DPU_ASW Configuration Control Issues

TITLE:	DPU ASW Configuration Control - Issues		
Date:	25/03/2020	Issue:	2.0
Reference:	EUCL-OPD-CS-7-001		
Custodian:	Eduardo Medinaceli

Change Log

Ktc 32.jpg

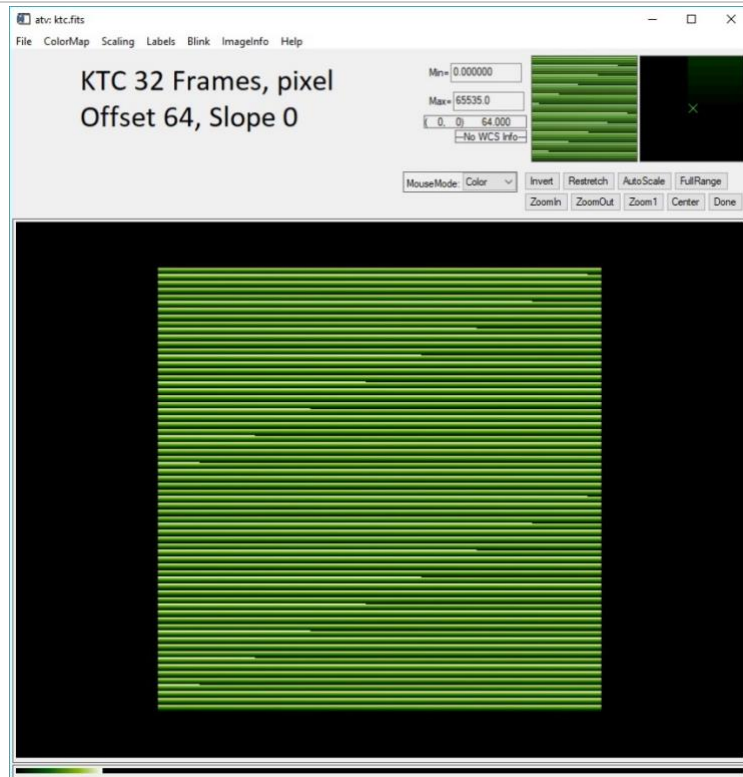
added consistency tests in the command

```
inside the KTC loops added checks on paramaters:
command register SCE_CMDREG; to check that the command was accepted
exposure status, register EXP_SCE_STATUS; to check if the exposure has finished
if both are OK, after a series of tests cknum, then continue with the next ktc-cycle (next exposure)
cknum = 64U; // Number of verifications for exposure termination, hardcoded
the time gap between exposures (ktc-cycles) is 100 ms
for (ii = 0; ii < cknum; ii++)
{
    taskDelay(sysClkRateGet() / 10); // Wait (200/10)*5 = 100 mSec
    ReadSCE(dcu_id, SCE_CMDREG, 1);
    temp_data1 = *aux_pnt; // Get current SCE CMDREG contents
    ReadSCE(dcu_id, EXP_SCE_STATUS, 1);
    temp_data2 = *aux_pnt;
    temp_data2 = temp_data2 & ST_MSK;
    if ( (temp_data1 == 0) && (temp_data2 == 0) )
    { break; // The current KTC exp is terminated go ahead with next ktc interaction }
```

CPU_MBE.png

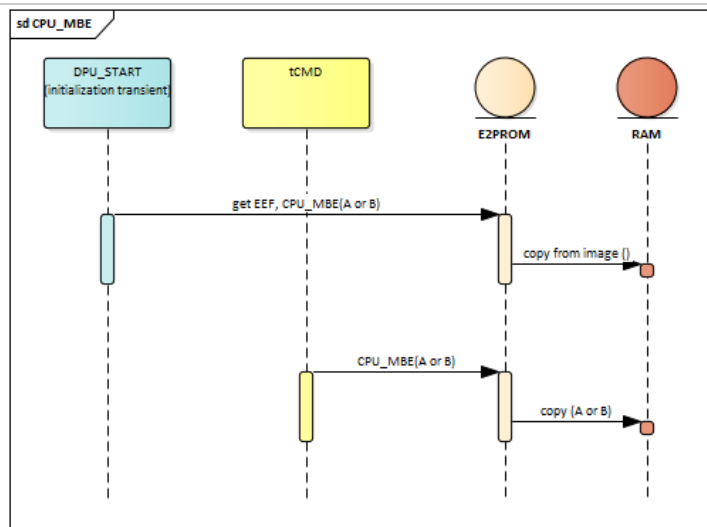
```
added to Supervisor.c in DPU_Init()
/* copy EEF from E2PROM (N or R) to RAM (to prevent misalignment), if fails keep RAM version */
res = CPUMBE(EEF_SEG_TYPEA);
if (res != OK)
{
    ERRORLOG(CPUASW_ESEGTYPE);
    res = CPUMBE(EEF_SEG_TYPEB);
    if(res != OK)
    { ERRORLOG(CPUASW_ESEGTYPE); #ifdef ASW_DEBUG printf("CPUMBE: using EEF_boot_tab from RAM \n");
    #endif }
    else
    { #ifdef ASW_DEBUG printf("CPUMBE: Copy EEF_boot_tab from EEF_SEG_TYPE = (CPUMBE) %d \n",
    EEF_SEG_TYPEB); #endif }
    }
    else
    { #ifdef ASW_DEBUG printf("CPUMBE: Copy EEF_boot_tab from EEF_SEG_TYPE = (CPUMBE) %d \n",
    EEF_SEG_TYPEA); #endif }
```

[EUNIDPUASW-108] Processing m chi2 rounding Created: 10/Jul/19 Updated:
10/Jul/19 Resolved: 10/Jul/19

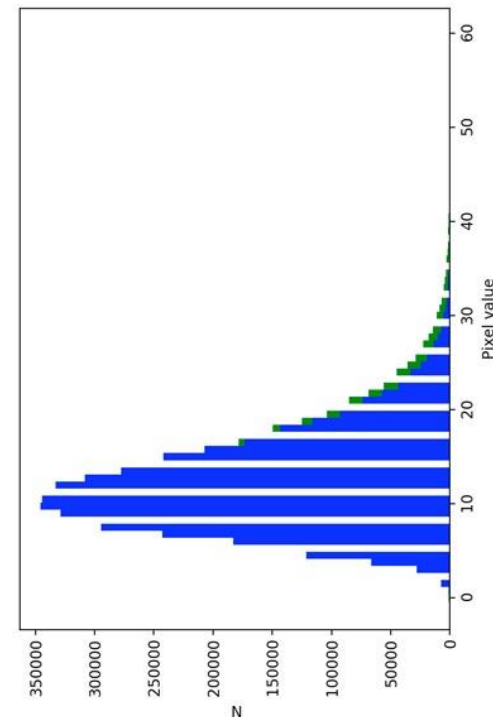
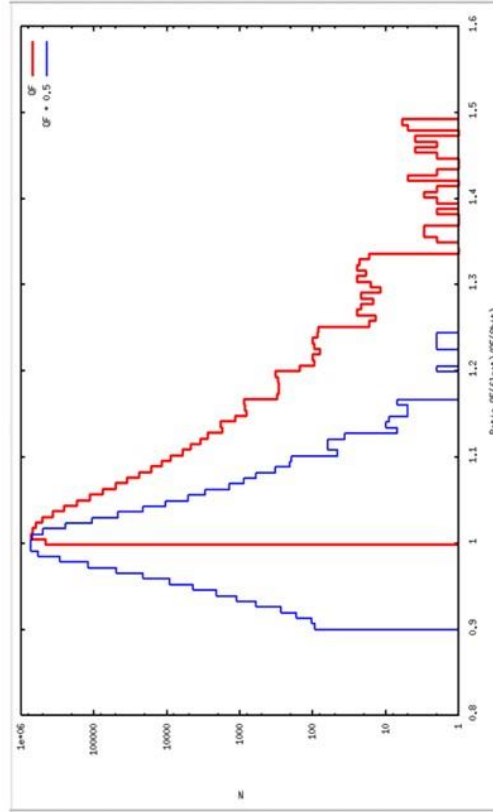
Using data from LAM campaign: nisp_em_test_NOM_20190417_134424_00002_000001.lv1
Off-line processing performed with following arbitrary parameters RON=25 (e⁻) GAIN=1.7 e⁻/ADU

Blue: theoretical χ^2 value for 13 dof

Green: QF from DPU processing

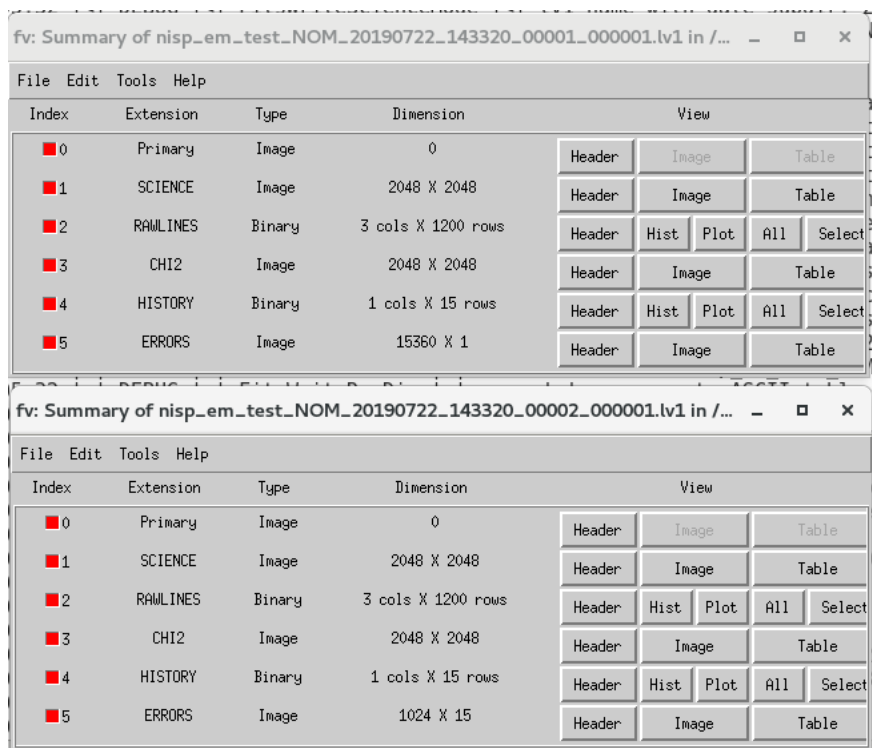
but the size was not correct, the correct one is:

```
ErrFlagSizeNgroups = DP_ERR_TAB_SIZE * dithConfTabLocal.Exposures[nExp].Groups;
```

MASTER delay of 500 [ms] case

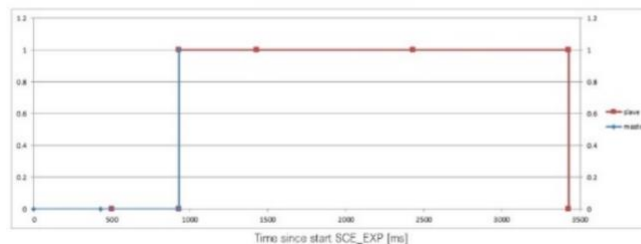
New Synchronization Mechanism
extreme limit cases

SLAVE delay of 500 [ms] case
(unchanged)

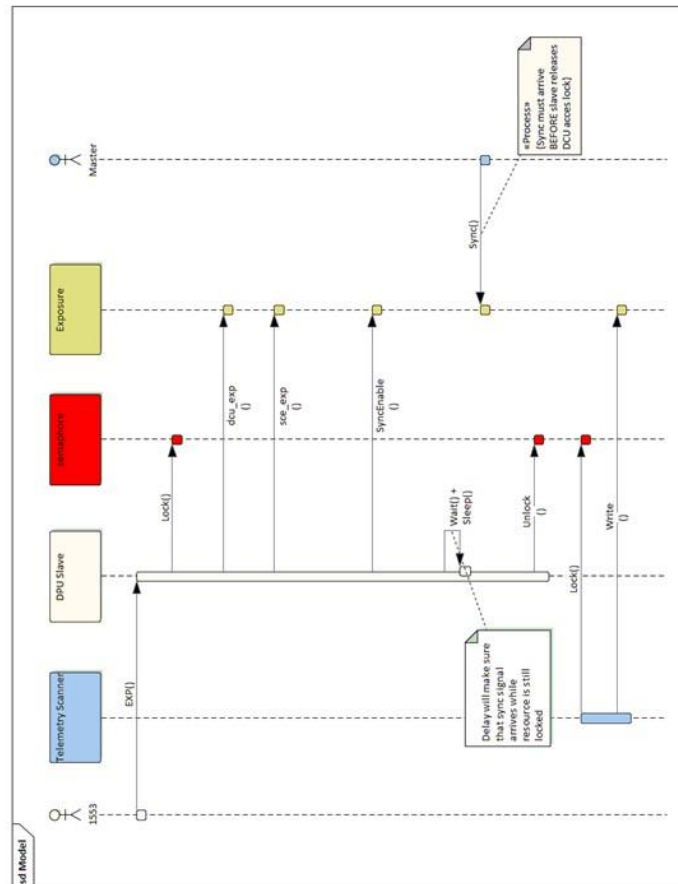
proposal:

- add a wait of 1s (after DPU internal operations) on the Slave unit
no effect on the 2s constraint because the acquisition length is from Start() to SyncSend()

```
uint16_t delay_Global = 1000 ms;
if (isMaster_Global == ASW_TRUE)
{
    res = SyncSend();
}
else
{
    taskDelay(delay_Global); // new code
}
```
